UNITED STATES PATENT AND TRADEMARK OFFICE

APPLICATION NO.	FILING DATE	FIRST NAMED INVENTOR	ATTORNEY DOCKET NO.	CONFIRMATION NO.
10/049,272	02/06/2002	Gabriel Daemon Engel		7736

Office Action Summary	Application No. 10/049,272	Applicant(s) ENGEL ET AL.	
	Examiner Kevin M. Nguyen	Art Unit 2629

FIG.3

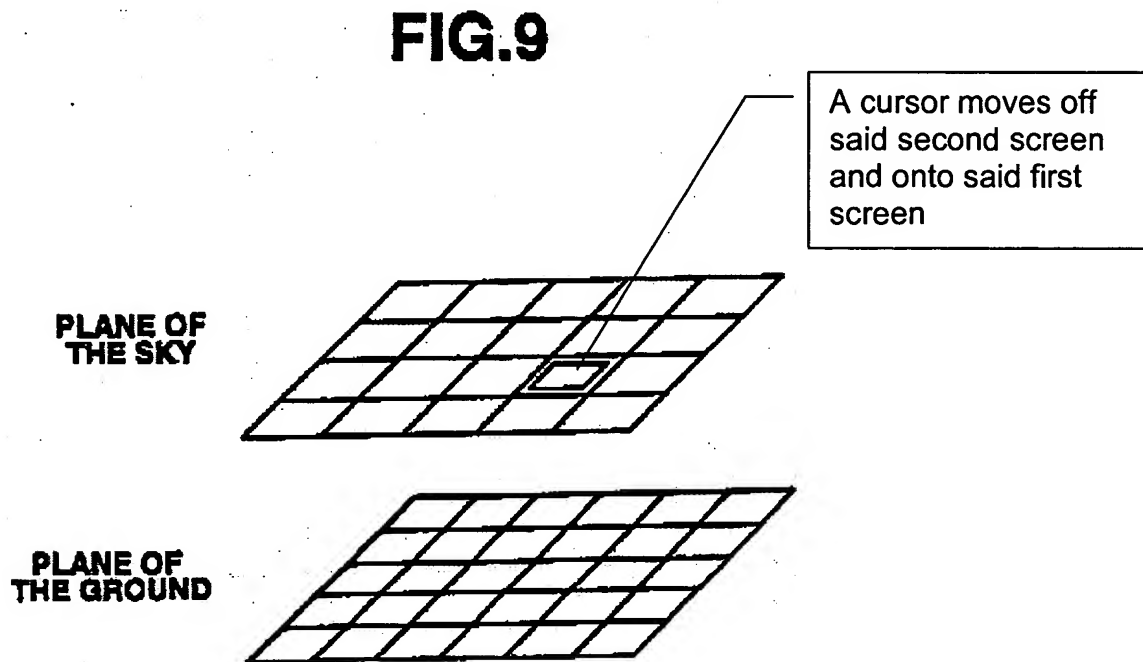
6. As to independent claims 22 and 53, figure 3 of Hinami discloses a visual display system associated with a method, the visual display system comprising:

a plurality of discrete screens spaced physically apart from one another *[a plane of a sky screen is separately spaced from a plane of a ground screen]*, each of the screens having a 2-dimensional plane *[each of said screen comprises x and y coordinate plane]*, at least one of said screens-being viewable through at least one of the other screens *[an operator "A" sees through a three dimensional virtual space, see col. 9, lines 27-33, and col. 10, lines 35-50 for more details of the explanation];*

a visual indicator *[a cursor is on the plane of the sky screen, see Fig. 9];* and
an input device *[a game controller (2b), fig. 1]* moves the visual indicator off the 2-dimensional plane of one of the plurality of screens and onto another one of the plurality of screens *[fig. 9 shows the cursor is on the plane of the ground screen is moving to the plane of the sky screen, or the cursor is on the plane of the sky screen is moving to the plane of the ground screen, col. 11, lines 50-65 for further details of the operation].*
